ENCLOSURE 2

SAFETY EVALUATION BY THE OFFICE OF NUCLEAR REACTOR REGULATION
RELATED TO THE INSERVICE TESTING PROGRAM AND REQUESTS FOR RELIEF

BYRON STATION, UNITS 1 AND 2

DOCKET NOS. STN 50-454 AND STN 50-455

Figure 1

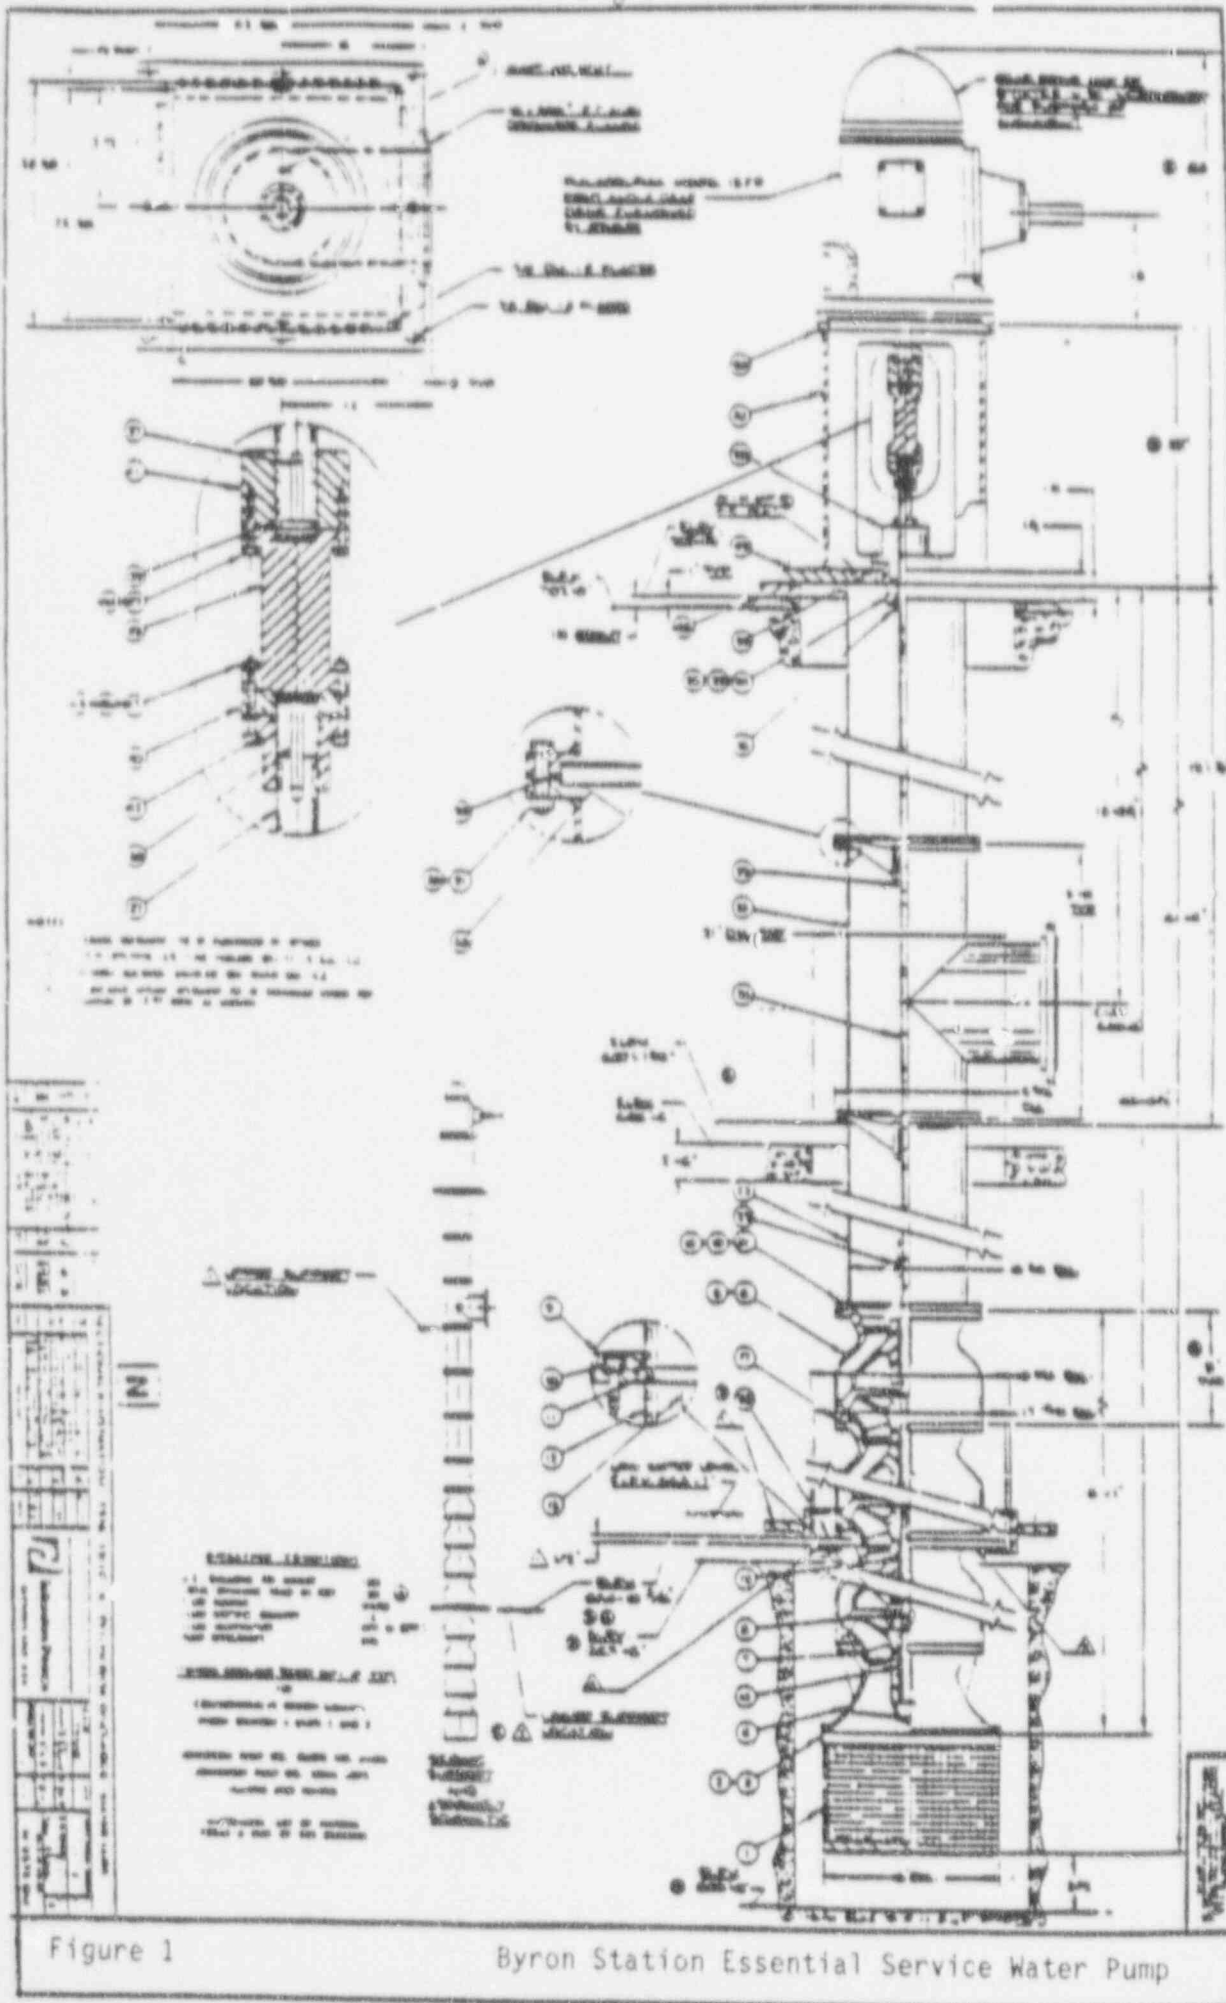
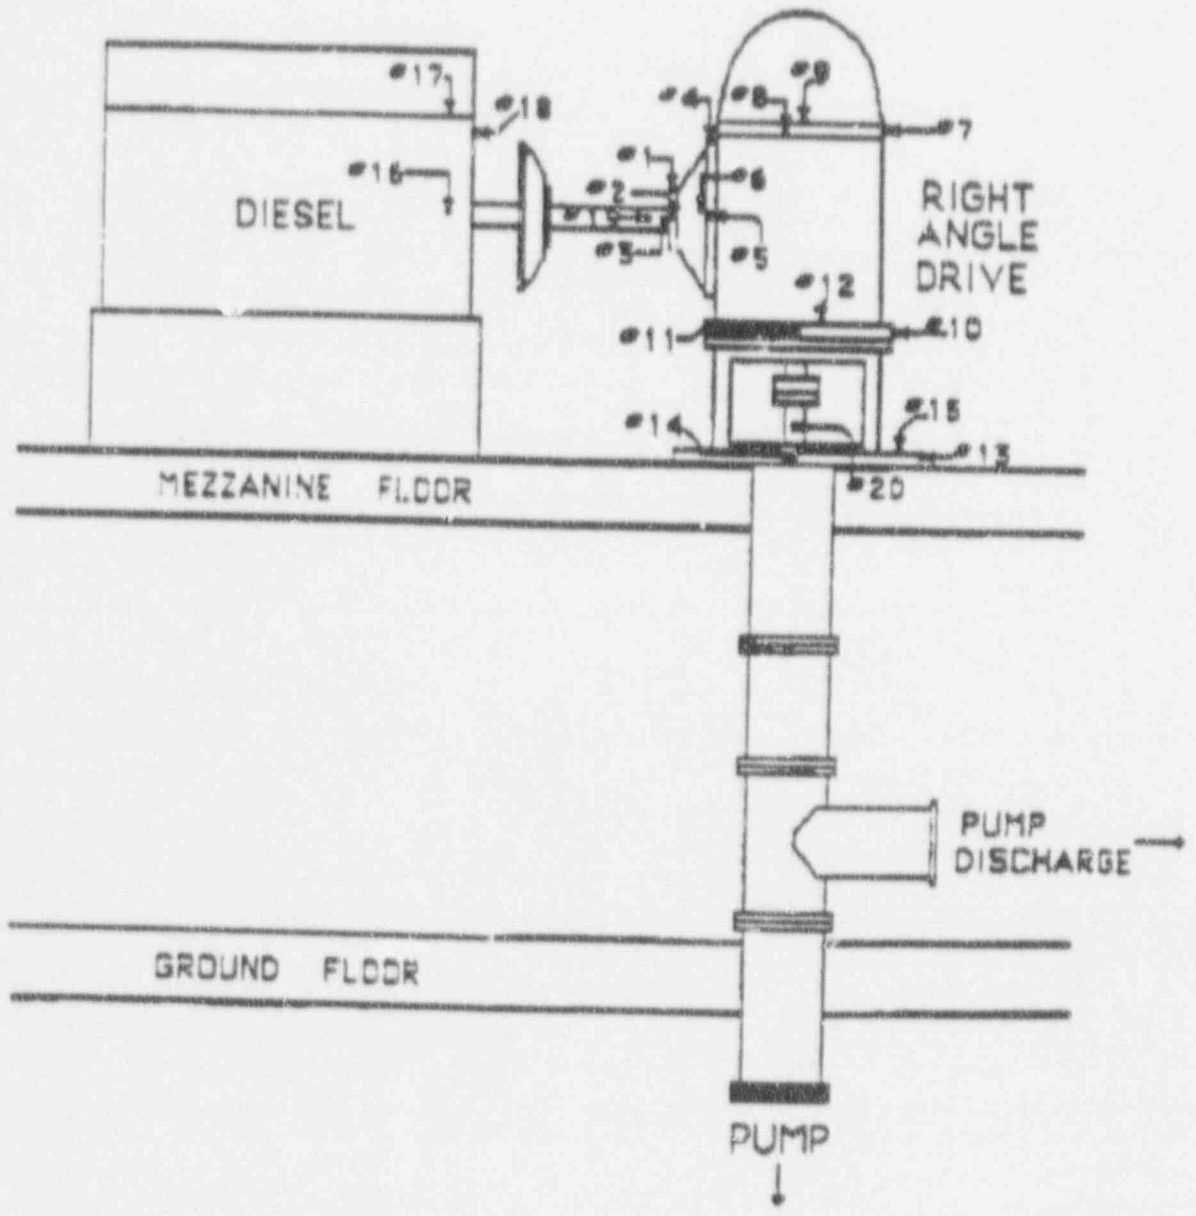
The Essential Service Water Pumps OSX02PA & B are of a very unique design (See Figures 1 and 2). The pump is attached to a horizontal diesel driver via a right angle gear drive, and the gear drive is located approximately 39 feet above the pump. This configuration assures pump operability during the design basis flooding of the Rock River. As would be expected, this extreme configuration results in vibration characteristics which are different from pumps of a more conventional design. The vibration levels for these pumps are consistently higher than the commonly expected values. These pumps exhibited higher than usual vibration levels at the time of their installation (approximately 0.4 - 2.45 in/sec for the gear box and approximately 0.20 - 0.25 in/sec for the pump), at which time they were verified by the vendor to be operating properly, and to have continued to display high vibration levels throughout their service life.

Also characteristic of these pumps is the fact that the gear box vibration levels are consistently higher than the pump vibration levels. The licensee proposed that, in order to properly monitor this uniquely designed pump, separate acceptance ranges be used for the gear box and the pump. The vibration levels for the pump, though consistently higher than those for conventional pumps, display no significant upward trend over a period of approximately six years.

This is significant evidence that these vibration levels are characteristic of this unique design and do not indicate pump degradation. However, the licensee proposed that tighter acceptance criteria be used for the pump than for the gear box in order to detect any degradation that may occur in the future. Based on performance data, Byron Station proposes that the following ranges be utilized to monitor vibration levels for OSX02PA & B (where V = the vibration velocity [in inches per second] and Vr = the reference vibration velocity [in inches per second] established when the pump was known to be operating acceptably):

Since the gear box normally exhibits relatively high vibration levels, the use of greater than 0.325 inches/second "Alert" range as in OM-6 would not be practical in that it would require doubling the test frequency when the vibration velocity is normal. Also, complying with greater than 0.7 inches/second "Required Action" range as in OM-6 would not be consistent with several years of empirical data which show vibration velocities to be in this range on several occasions without apparent pump failure or damage. The proposed "Alert" and "Required Action" limits appear reasonable considering the six years of test data; however, because these pumps are of a unique design with unusually high vibration characteristics, obtaining the vendor's concurrence of these limits is appropriate. The empirical data combined with the vendor's concurrence should provide reasonable assurance that applying the proposed action limits will not compromise the operational readiness of these pumps.

Based on the determination that it is impractical to use the "Alert" and "Required Action" ranges of OM-6 for the OSX02PA and B gear box and considering the licensee's proposed alternative and the burden on the licensee if the OM-6 requirements were imposed, relief may be granted as requested for the gear box pursuant to 10 CFR 50.55a(g)(6)(i), provided the licensee obtains the vendor's concurrence of the proposed ranges and complies with all other OM-6 vibration measurement requirements.
